# 2004 - 2009 Cadillac XLR XLR-V: Recall Notice: #15643: Special Coverage Adjustment - Airbag Light On

## #15643: Special Coverage Adjustment - Airbag Light On - (Apr 21, 2016)

**Subject:** 15643 — Special Coverage  
Adjustment – Airbag Light On

**Models:** 2004 - 2009 Cadillac XLR  
2005 - 2013 Chevrolet Corvette

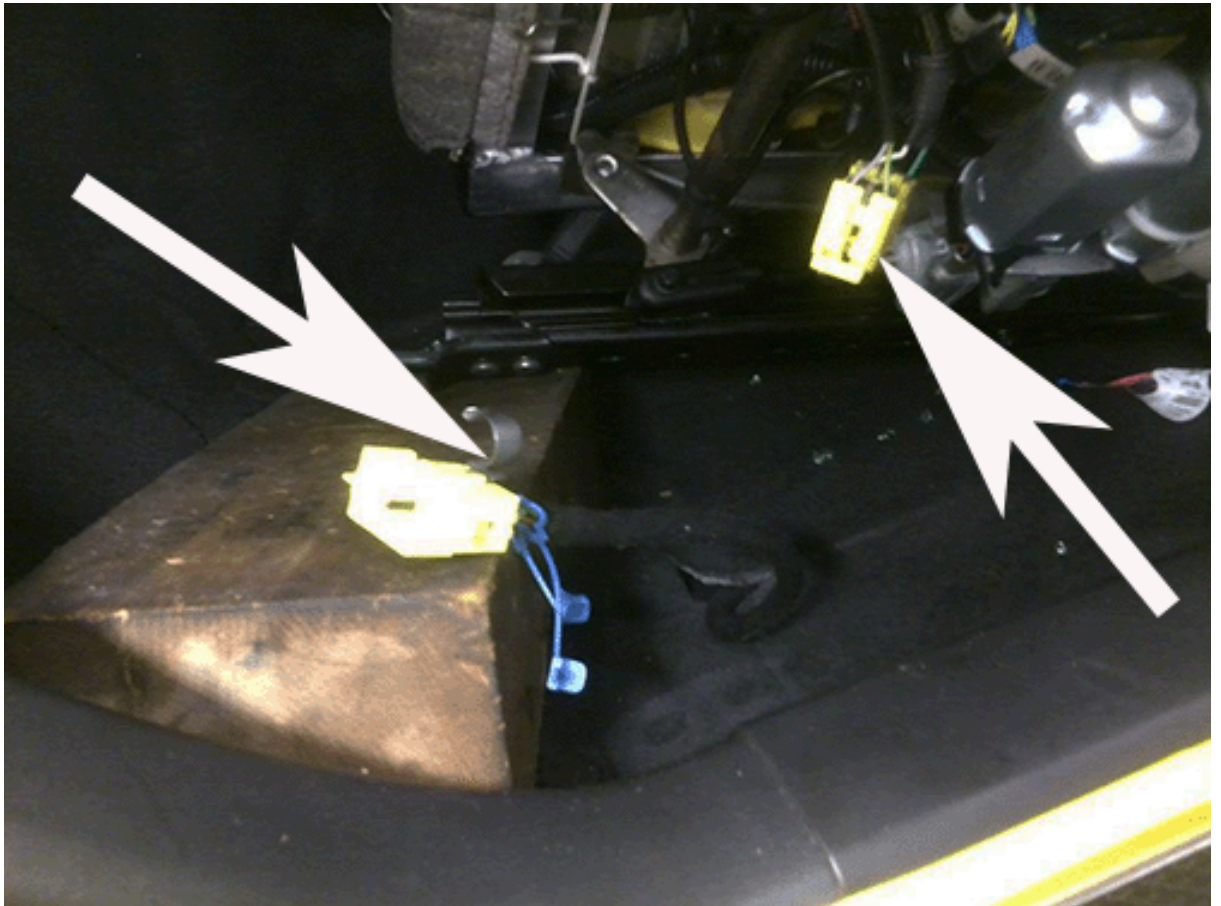
1. Using wood blocks or similar material, tilt and support the seat in the vehicle as shown.

1. Locate the yellow wire connector at the rear cross bar on the seat frame. Remove the connector from the seat cross bar by releasing the metal clip.

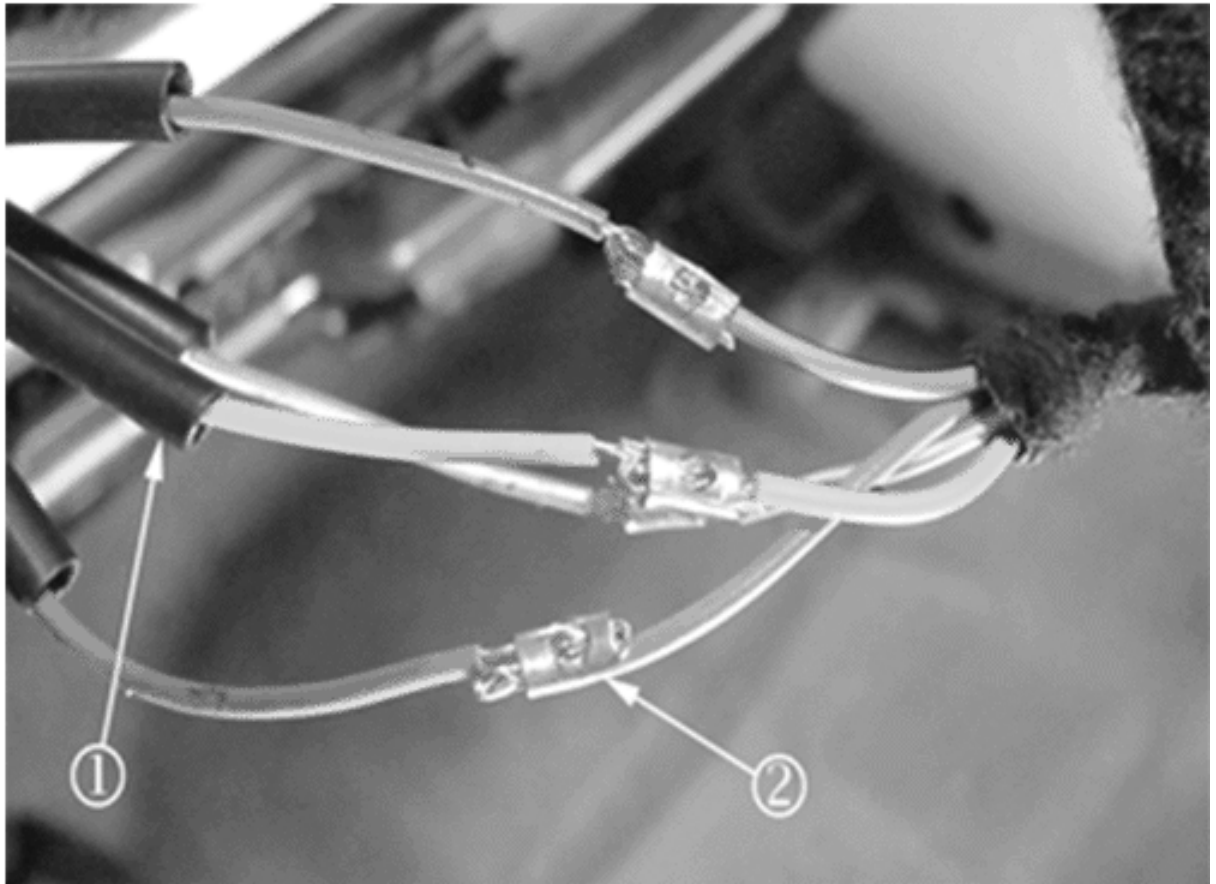
1. Make a list of how the wires relate from the body side harness to the seat harness. It critical that the wire pairs

are identified correctly to avoid splicing incorrect wire pairs. *THE WIRE COLORS ON THE BODY SIDE HARNESS AND THE SEAT SIDE HARNESS ARE NOT THE SAME.*

2. Using side cutters, cut the four wires on the body and seat harness as close the connector as possible.

1. Strip off approximately 13 mm (1/2 in) of insulation from the wiring ends. Fold the wires.

1. Add one approximate 38 mm (1.5 in) section of heat shrink tube to each of the four wires (1).
2. Join the four wires together. Use the wire color list created above to determine correct wire position.
3. Crimp a splice clip over the joined wires using Special Tool J-38125-8, nest F. Verify the crimp quality. Repeat this crimp process on all four wire connections (2).

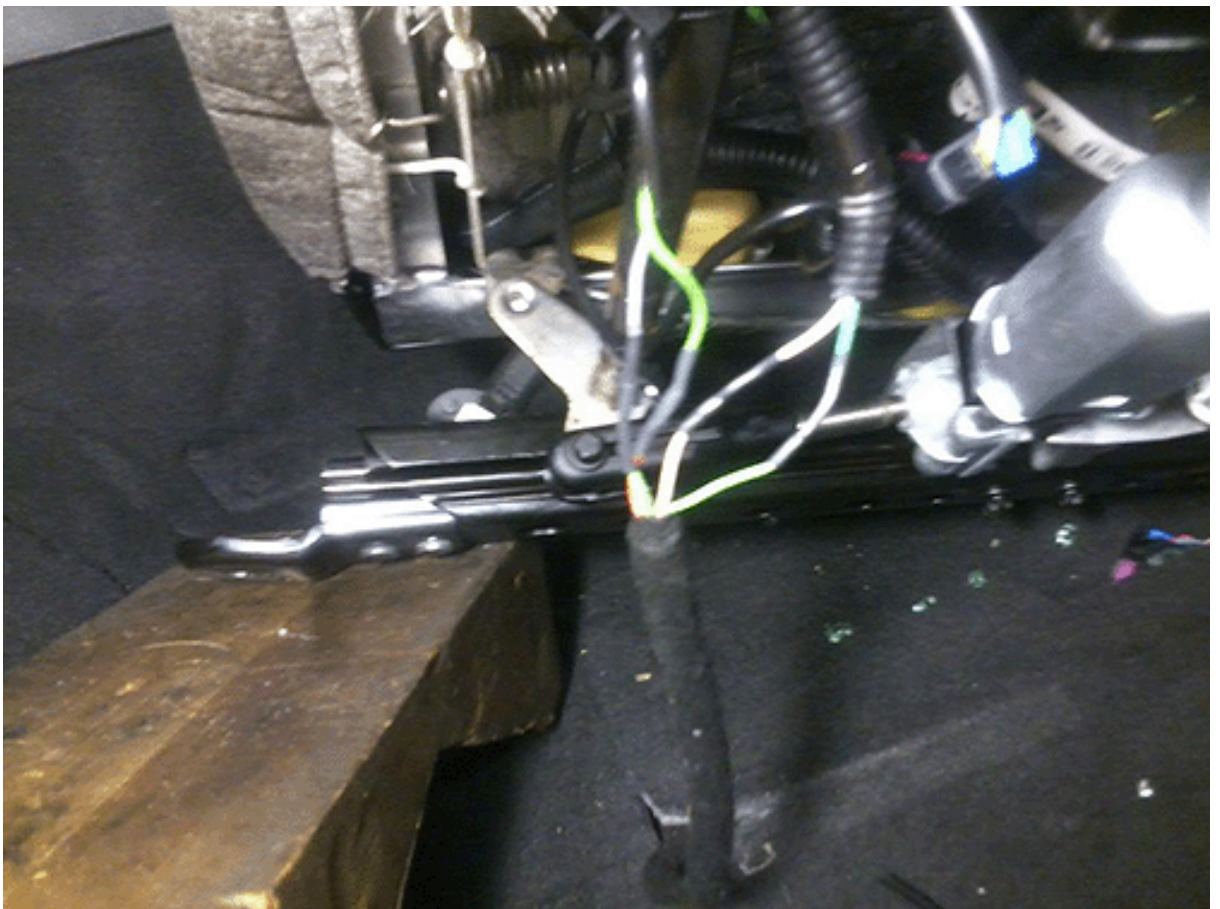
1. Solder all four crimp and splice clips using the Ultratorch, part number J-38125-5, or another butane fueled soldering iron.

1. Center the heat shrink tube over all four splices and shrink/seal the heat shrink tube securely over the splice crimp and insulated wires.

1. Wrap woven polyester electrical tape (PET) or equivalent anti-abrasion tape around the spliced section of both wires. Continue to wrap the harness as shown.

1. Wrap two sections of yellow electrical tape over the polyester electrical tape on both sides of the splice.
